State of California  
AIR RESOURCES BOARD

**PROPOSED CONTROL MEASURE FOR  
OCEAN-GOING VESSELS AT BERTH**

**FINAL STATEMENT OF REASONS**

**November 2020**

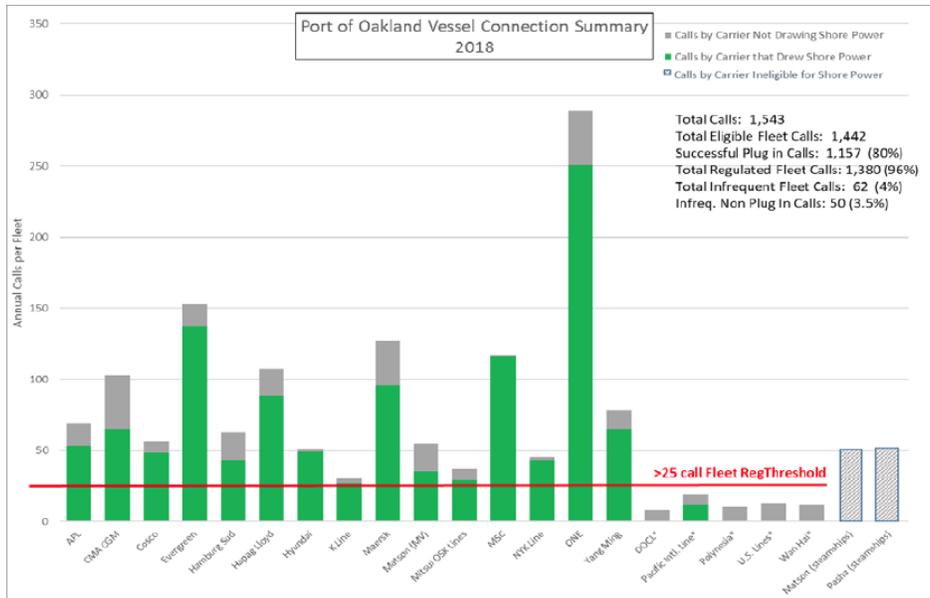
**Comment:** "Freight Analysis Framework (FAF) Forecast for Future Vessel Traffic Growth is Unrealistic. As mentioned during the January 24, 2019 in person meeting, Chevron stated that a 46.5% growth rate by 2050 is not feasible and does not reflect the mass balance and operational constraints that exist for Richmond Refinery. Any small growth in marine traffic is likely to be in way of product leaving the facility which does not require vessels to pump, so additional at berth emissions would be limited to hotel and ballast water treatment loads, significantly less than pumping loads."

"Consequently, CARB should not rely upon the FAF Report as a future forecast for vessel activity for RLW and the Richmond Refinery. Based on our past 10 years operation, we would not expect greater than 1 % growth over a 10-year period. Forecasting it to 2040, that would equate to a vessel growth rate of 1.03 (3% relative to 2016)." (22.33)

**Agency Response (22.33):** The emissions inventory documentation includes a description of the growth source for tankers (and all other categories) in Section 4.1. If WSPA has a recommendation for an alternate source of forecasting, CARB staff would certainly consider them in future inventories (as has been done for the Ports of Los Angeles and Long Beach, Port of Hueneme, and is being considered for the Port of Oakland). However, simply using historical trends without any forecasting methodology ignores the projected demand for imports and exports, as well as the shifts in production location and pathways, change in value and costs of transport, and other aspects explored in-depth in the FAF forecast.

The emissions inventory does not forecast vessel visits specifically; it forecasts power use of visiting vessels. Therefore, if vessel visits do not increase, but more product is delivered on tankers closer to capacity or larger tankers, the time loading or unloading product will increase and the power will increase relative to the baseline.
